REPORT COA2019-040
FILE NO. D20-2019-009

From: Chris Marshall
Sent: Wednesday, May 15, 2019 9:50 AM
To: 'phillip danek'
Cc: Quadri Adebayo; Richard Holy; 'fed45@hotmail.com', joe@keji
Subject: RE: Deferral meeting new and old drawing

DANEK BOATHOUSE
20 GRIFFEN DRIVE
COBOCONK, ONTARIO, CANADA

PROPOSED DEMOLITION
NEW BOATHOUSE
and RETAINING WALL

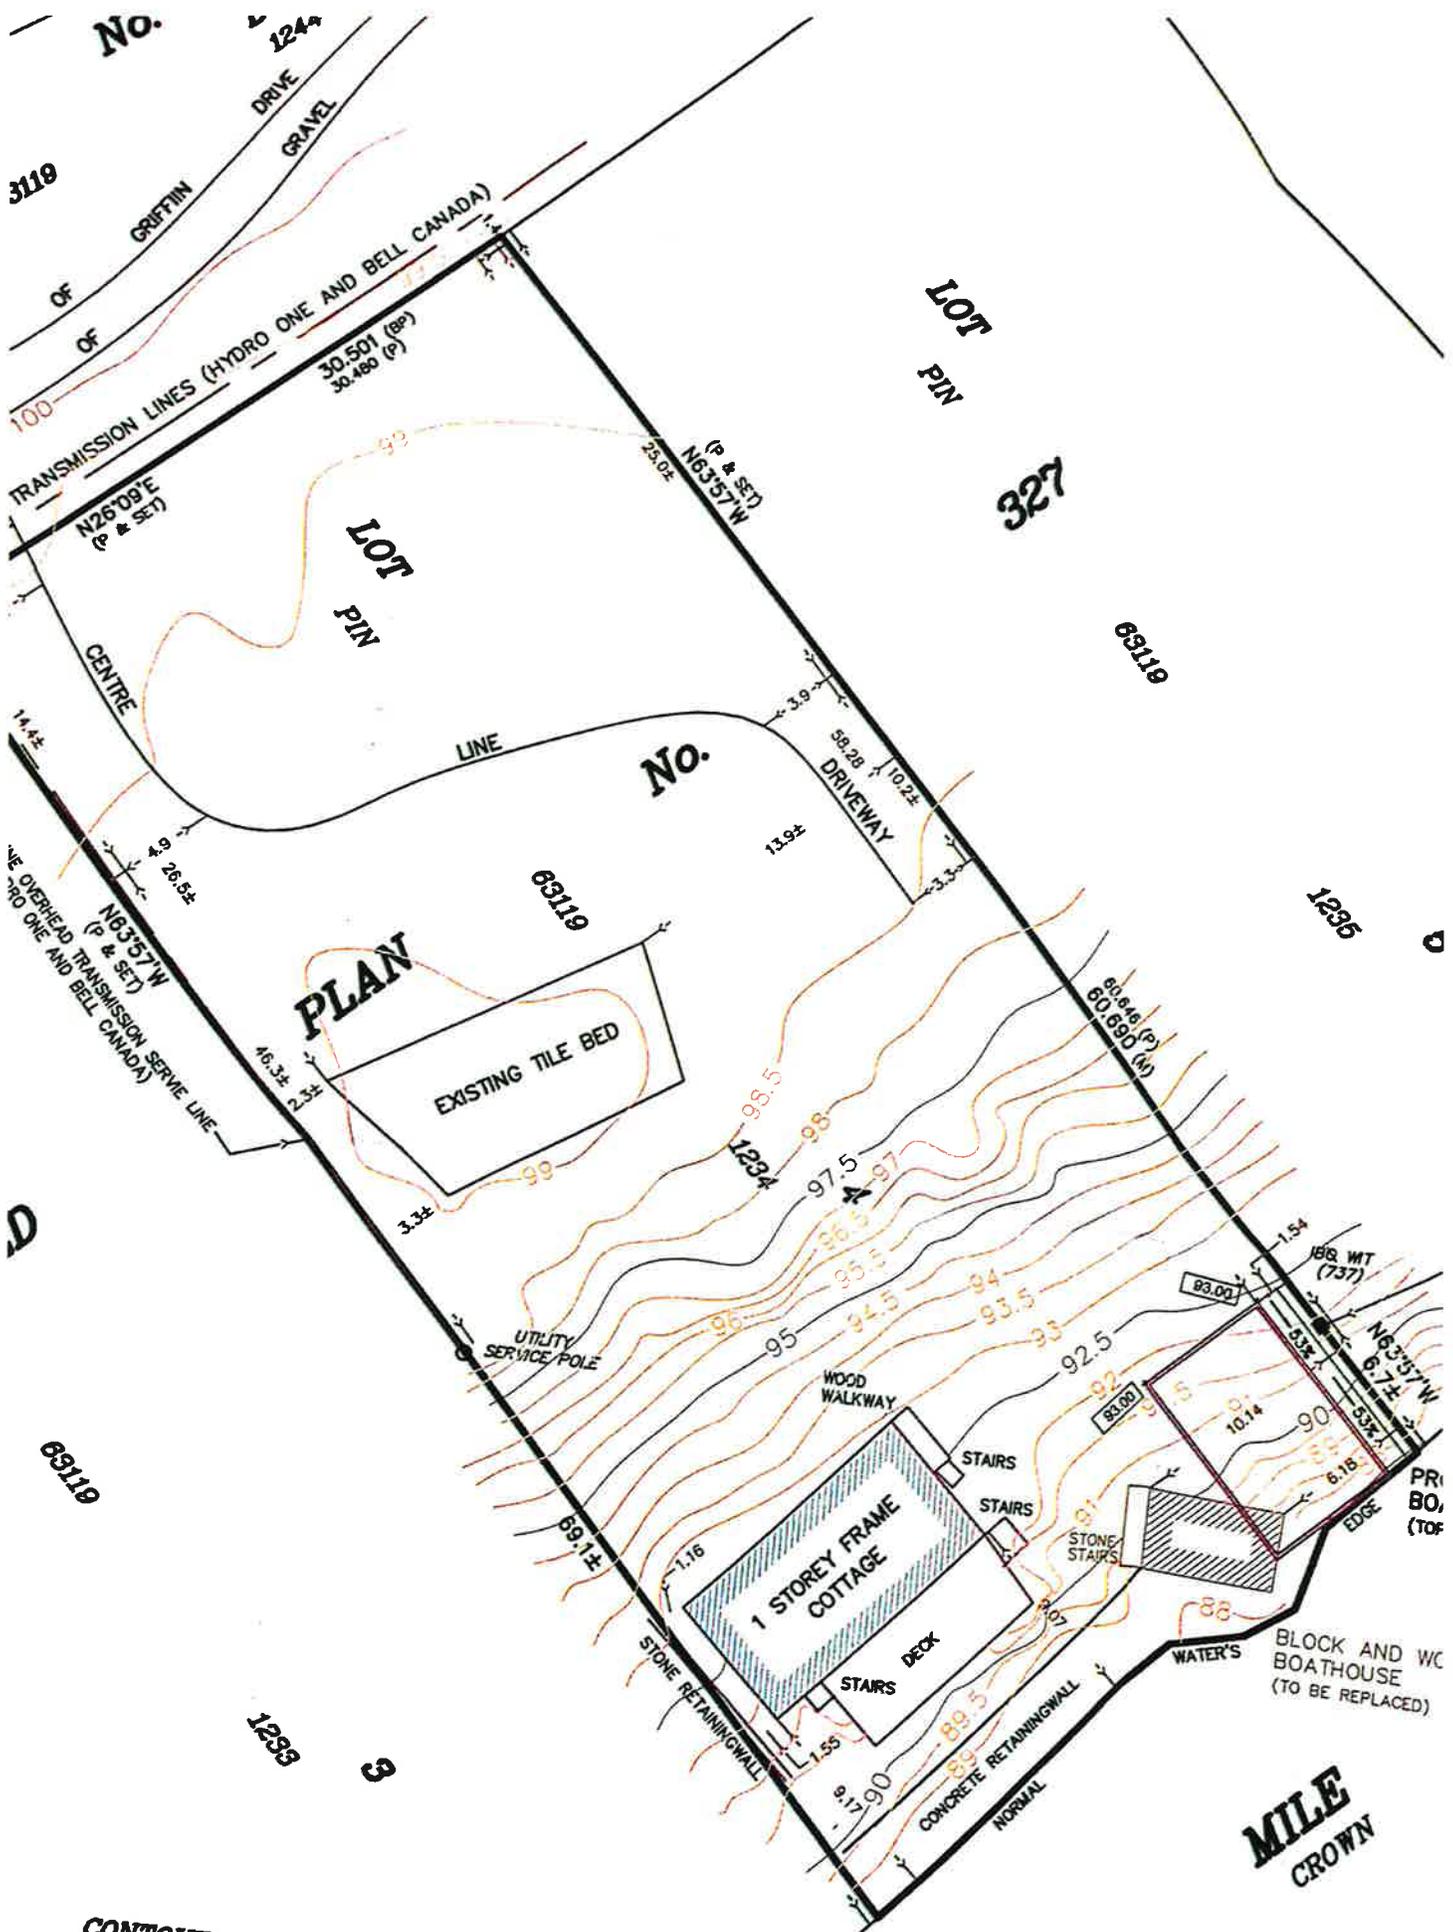
Here is a copy of the new survey with the correct shore line.

Sheet #
DANEK A2

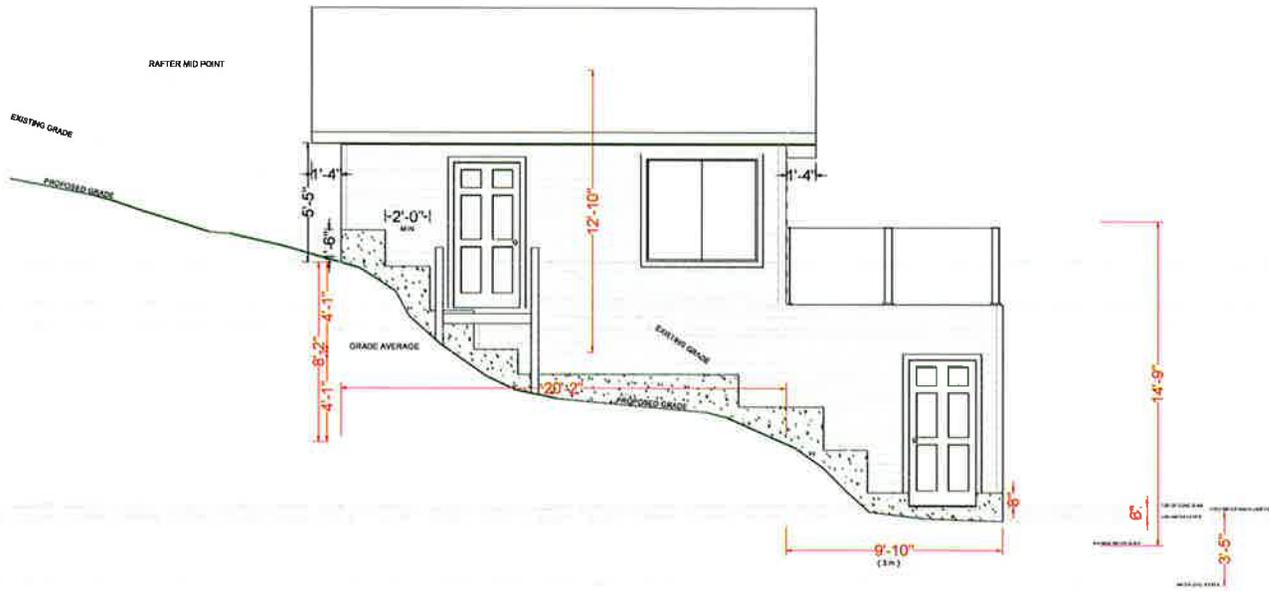
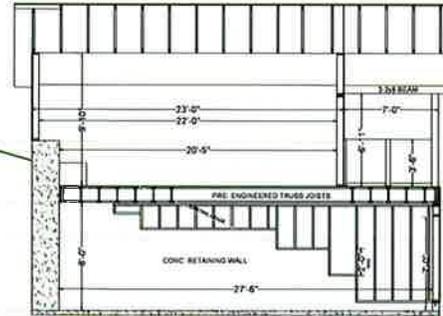
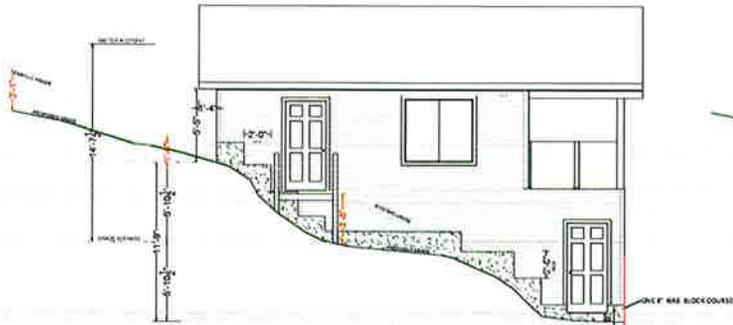
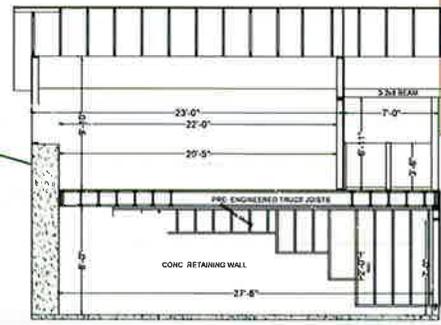
Hi Mr. Danek, thanks for your call sorry I missed you. I have spoken to Quadri and I am not sure what the misunderstanding is. The Zoning Bylaw is very clear that two storey boathouses are not permitted and that the height limitation is 4.5 m from the water level or 4.5 m from grade if you are building 3 m away from the water. It does not appear that either of your options meet these requirements. I have also been told that your neighbour is in opposition to your proposal and so is the Lake Association. I would suggest that you develop a design for your boathouse that meets the Bylaw as there does not appear to be any support for this variance from staff or the public.

There are two attachments, one being the original proposed boat house, and the new boat house moved back 3 meters. You can see that if I move the boat house 3 meters back, how much more I have to dig into the cliff, which would have a great impact on the land. The second attachment is what we did suggest back when we met in Dec, 2018. The original boat house proposed or the redesign back on Dec, 2018 are the best two choices, as they have the least impact on the environment and best use of the land as I am on a cliff. Please let me know what my next step is.
